Planning and Zoning Board Agenda October 13, 2020

SUBJECT: Site Plan – Hal Brady Recreation Center Maintenance Building: A request by Travis Hastay, P.E., of CHW, Inc., applicant and agent, for the City of Alachua, property owner, for consideration of a Site Plan to construct a $\pm 2,000$ square foot accessory structure (maintenance building) with associated stormwater and utility improvements on a ± 0.50 acre development area . Tax Parcel Number 03061-004-001 (Quasi-Judicial Hearing).

Planning & Community Development Department Staff Report

**RE: Hal Brady Recreation Center Maintenance Building (Site Plan)-
Development Review Team (DRT) Comments**

CITY OF ALACHUA
PROJECT: HAL BRADY RECREATION CENTER
MAINTENANCE SHED
SHEET TITLE: CONSTRUCTION PLAN

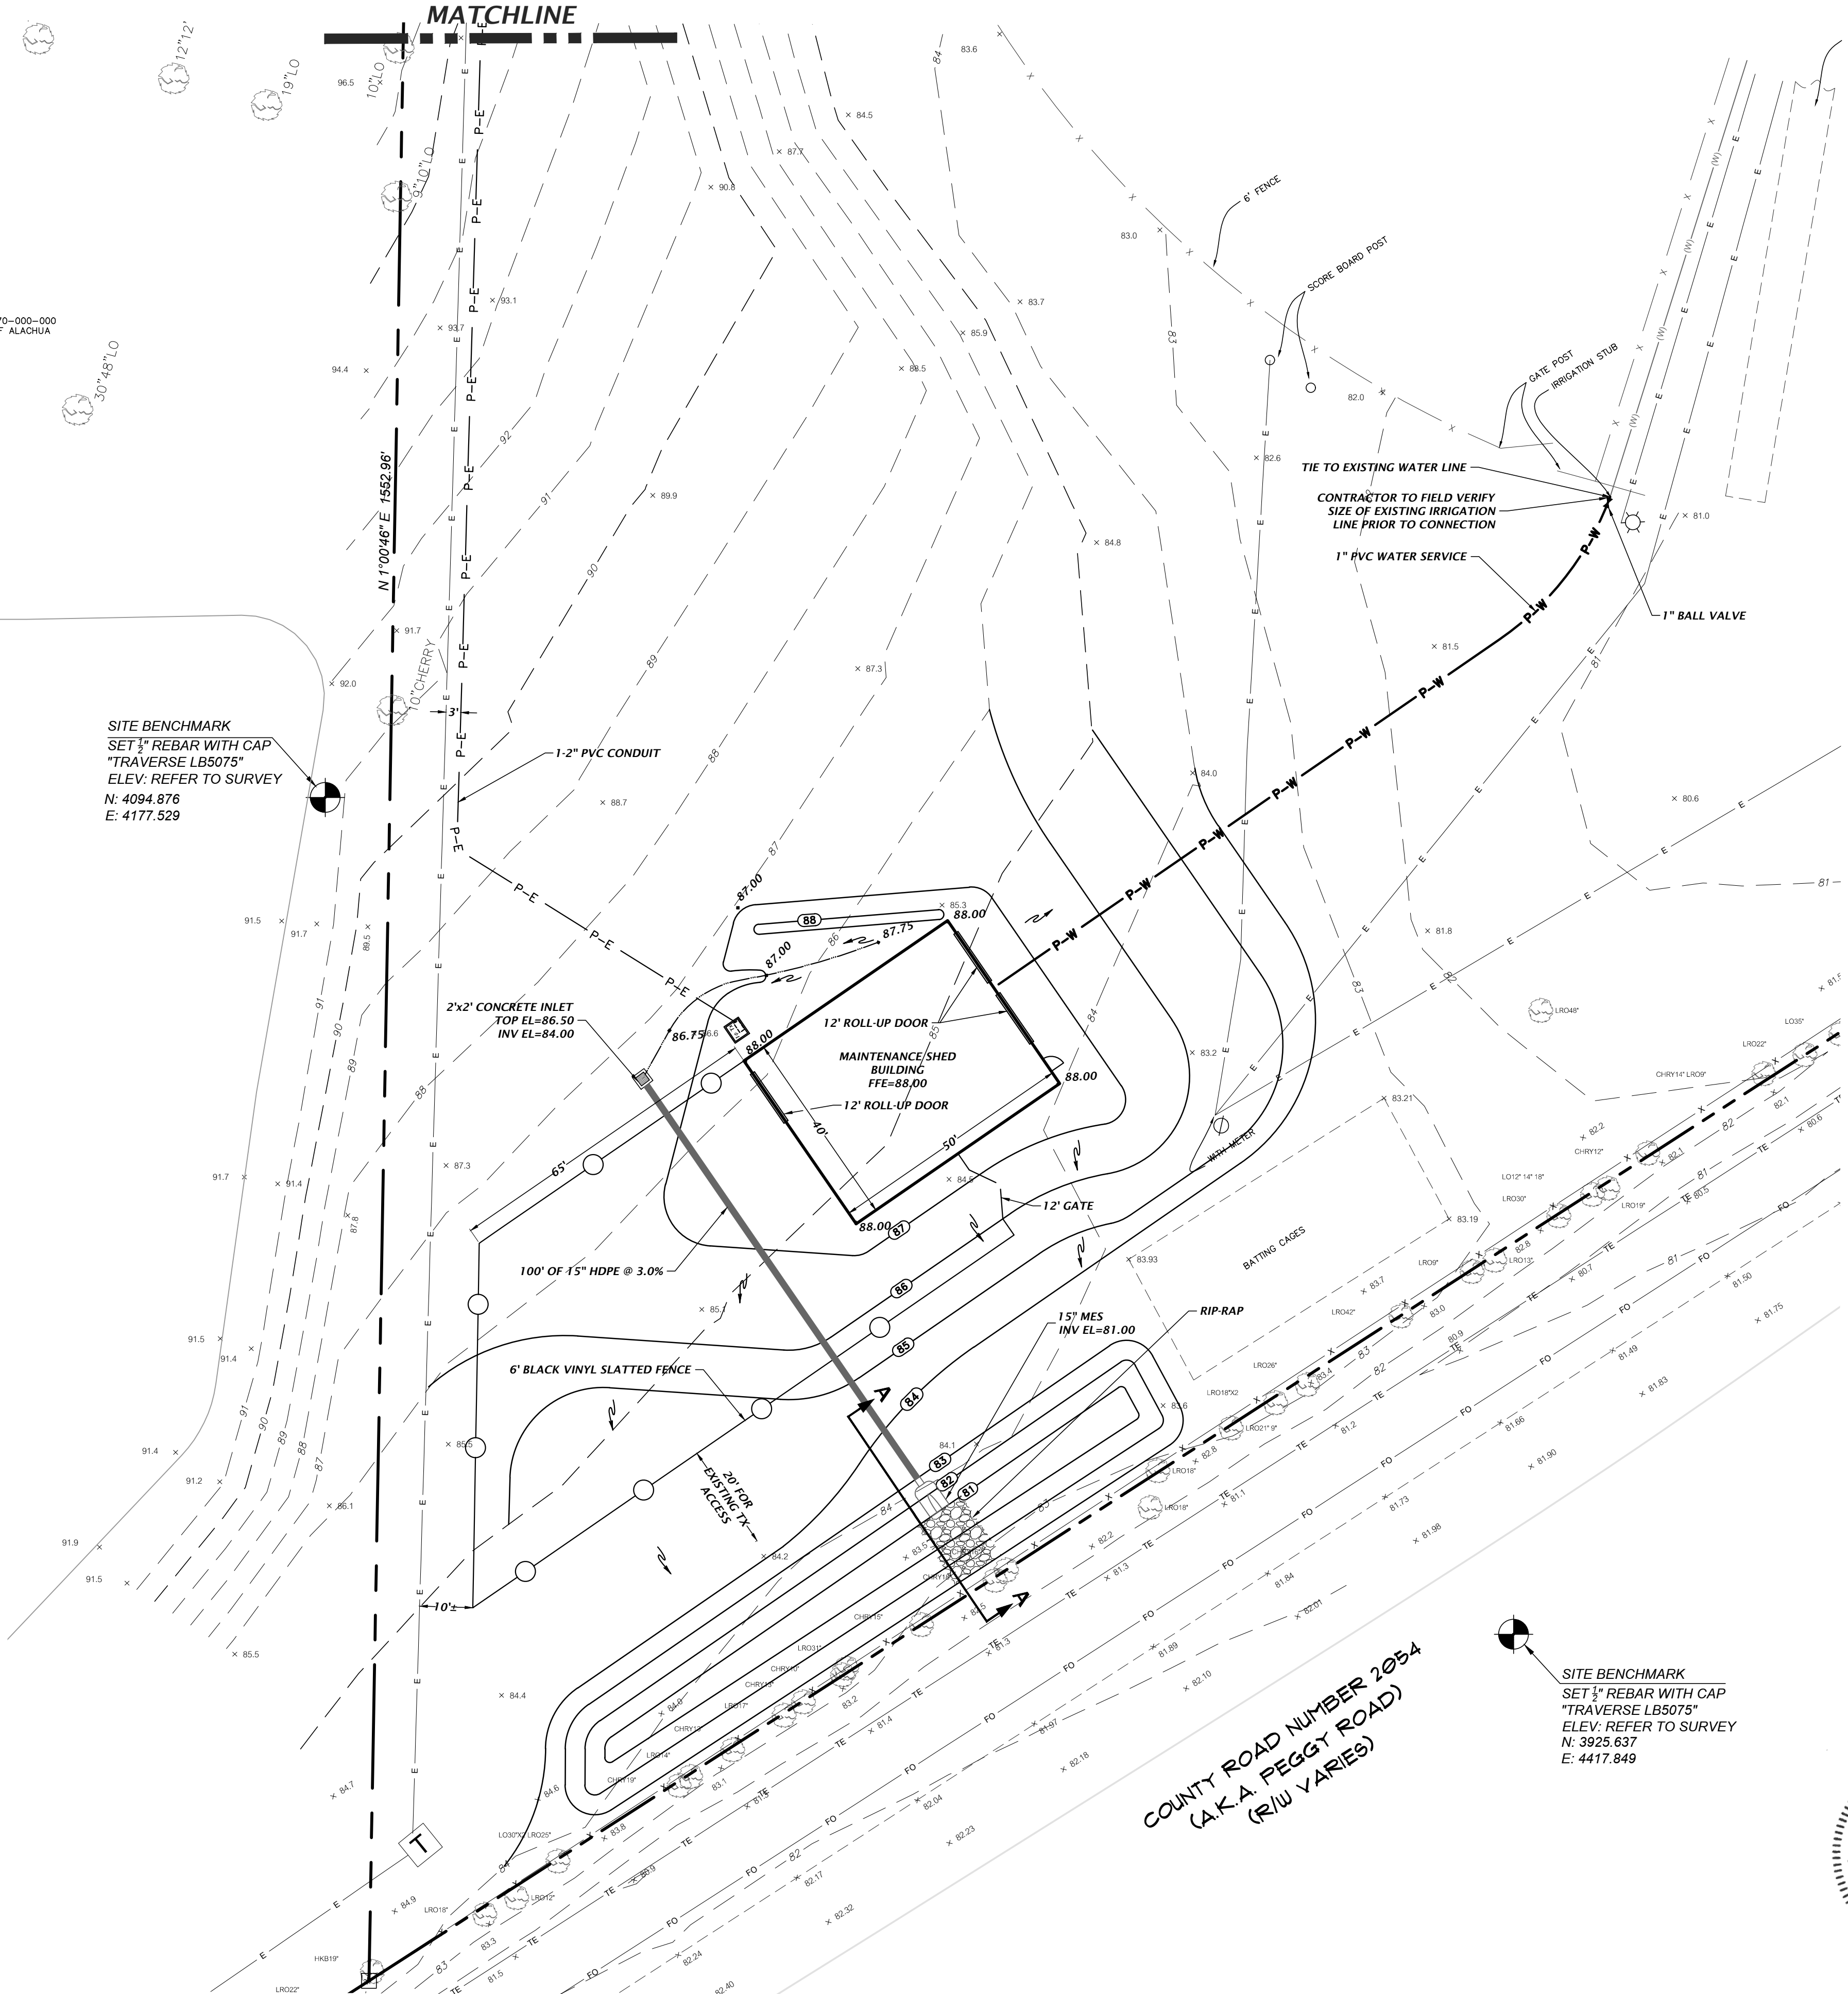
NO.	COMMENTS
	Approved as Noted.
2.	June 30th Submittal Comment Sheet C1.00 Please review the size of the 1-inch water supply line, which seems to be supplying only a water bibb. This reviewer does not know the design flow of the water bibb. But at 6 fps, the flow of about 16 gpm produces a head loss per 100 ft. of 16.5 ft. Since segment length is over 400 ft., pipe loss is close to 30 psi, which seems excessive. Suggest increasing water supply line size to 2-inch, unless demand, velocity and headloss calculations indicate otherwise. Aug 10th Submittal Comment Based upon new location and after conferring with COA staff, please decrease the water service line size to 1-inch. No re-submittal required at this time. See comment 11. Approved as Noted.
3	June 30th Submittal Comment Sheet C1.00, Electrical Design • The proposed electrical line is shown originating from a device that is not completely defined. A symbol (circular with diagonal line) is shown with text "meter". Please define or call-out this symbol. Is it a breaker box? • Text callout near the symbol is "WITH METER". Please confirm there is a meter, as COA electrical staff doesn't think a meter is there. • Please estimate the electrical load within the building in order to size (1) conductors and (2) circuit breaker at the breaker box. • Will the design include the required electrical work within the building? Aug 10th Submittal Comment See new comment 11.

8.	June 30th Submittal Comment Supplemental Comment: Sheet C1.00 As shown on Sheet C1.00, the new water supply line is over 400 ft. long and supplies only a hose bibb. Is there a nearer water supply, such as a sprinkler system, that can instead supply the hose bibb? If so, please confirm that the appropriate City staff find this approach acceptable. Aug 10th Submittal Comment Approved

NO.	COMMENTS
1.	June 30th Submittal Comment Sheet C0.10 Electric Service General Notes Notes 1 & 2: Please clarify the term "BY OTHERS". The reviewer assumes that the electrical design will be included with the construction documents, with the electrical design engineer being someone other than CHW. Water and Wastewater General Notes Note 12: Because this is a potable water line, the reviewer assumes that the PVC water pipe is NSF 61 approved and rated for potable water service. Please evaluate.
2.	June 30th Submittal Comment Sheet C1.00 Please review the size of the 1-inch water supply line, which seems to be supplying only a water bibb. This reviewer does not know the design flow of the water bibb. But at 6 fps, the flow of about 16 gpm produces a head loss per 100 ft. of 16.5 ft. Since segment length

NO.	COMMENTS
	is over 400 ft., pipe loss is close to 30 psi, which seems excessive. Suggest increasing water supply line size to 2-inch, unless demand, velocity and headloss calculations indicate otherwise.
3	June 30th Submittal Comment Sheet C1.00, Electrical Design • The proposed electrical line is shown originating from a device that is not completely defined. A symbol (circular with diagonal line) is shown with text “meter”. Please define or call-out this symbol. Is it a breaker box? • Text callout near the symbol is “WITH METER”. Please confirm there is a meter, as COA electrical staff doesn’t think a meter is there. • Please estimate the electrical load within the building in order to size (1) conductors and (2) circuit breaker at the breaker box. • Will the design include the required electrical work within the building?

NO.	COMMENTS
8.	June 30th Submittal Comment Supplemental Comment: Sheet C1.00 As shown on Sheet C1.00, the new water supply line is over 400 ft. long and supplies only a hose bibb. Is there a nearer water supply, such as a sprinkler system, that can instead supply the hose bibb? If so, please confirm that the appropriate City staff find this approach acceptable.

118 2" WATER SERVICE CONNECTION NTS

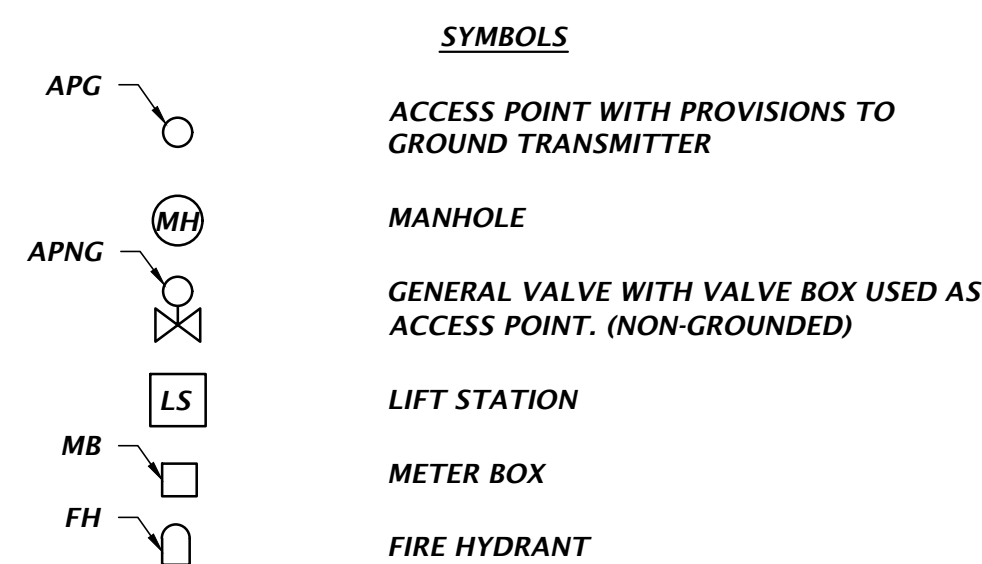
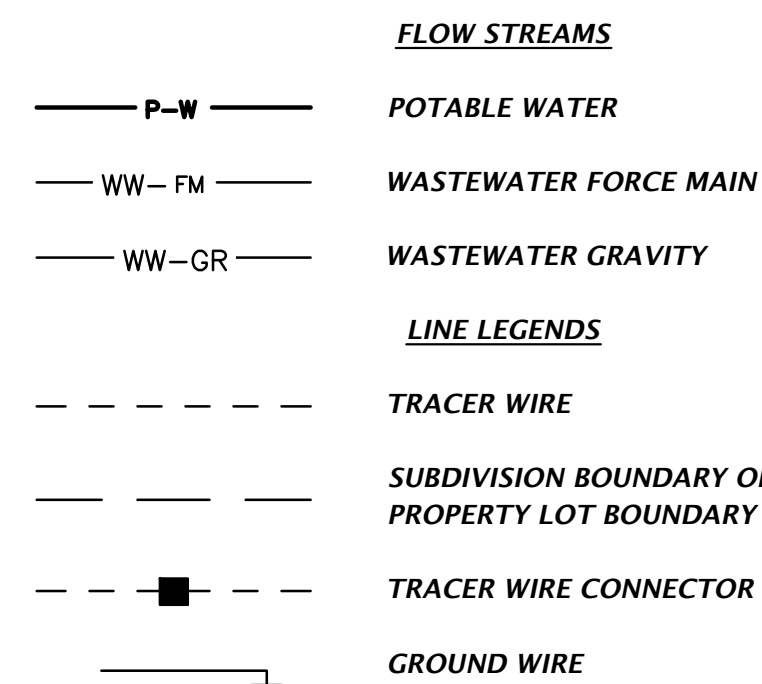
4.	June 30th Submittal Comment Please include all required design details. Use COA standard details as much as possible. It is expected that only a few design details will be required. • At the tapping saddle, consider using details 118 and 127. • Detail 506 – Typical Conduit Trench • Is a detail needed for the hose bibb, or will the device specification be sufficient? • Others if and as required.

4.	June 30th Submittal Comment Please include all required design details. Use COA standard details as much as possible. It is expected that only a few design details will be required. • At the tapping saddle, consider using details 118 and 127. • Detail 506 – Typical Conduit Trench • Is a detail needed for the hose bibb, or will the device specification be sufficient? • Others if and as required.

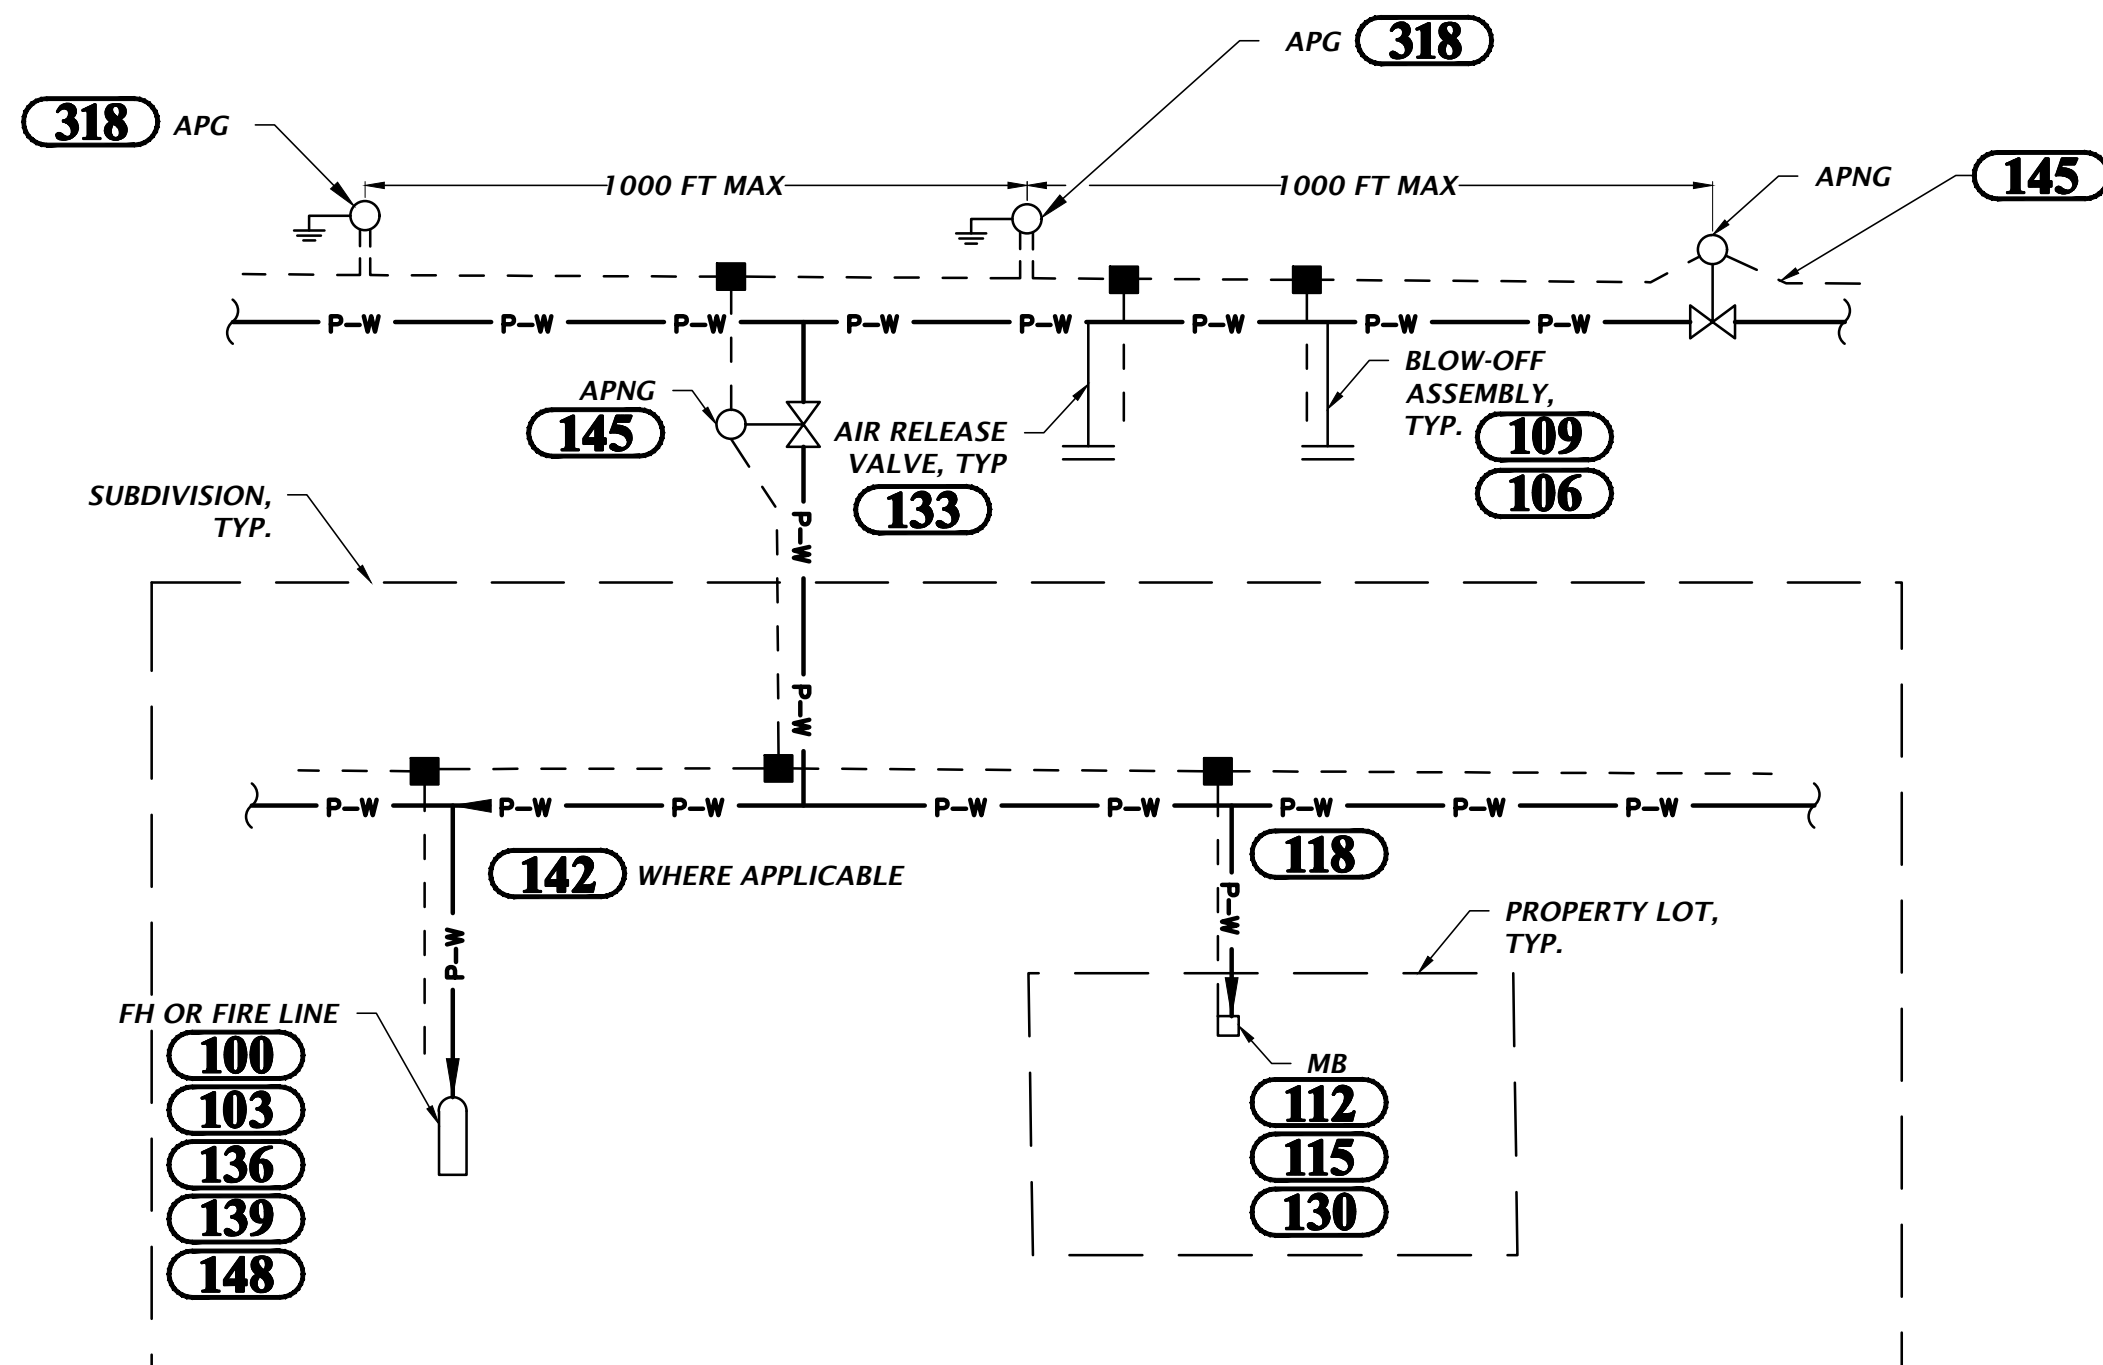
10.	June 30th Submittal Comment Supplemental Comment: Please add Detail 307, which is a cross-referenced painting detail. Aug 10th Submittal Comment Approved
11	New Comment Aug 10th Submittal Comment This submittal is suitable for presentation to the COA Planning Department for their review and approval. However, for this submittal to be suitable as a Bid Document, some changes would be required. For example, if the COA self-performs certain tasks, these tasks would need to be identified. No action is required by the design engineer at this time. However, when notified by COA, the design engineer will likely need to resubmit. Approved as Noted
END OF COMMENTS

10.	June 30th Submittal Comment Supplemental Comment: Please add Detail 307, which is a cross-referenced painting detail.
END OF COMMENTS
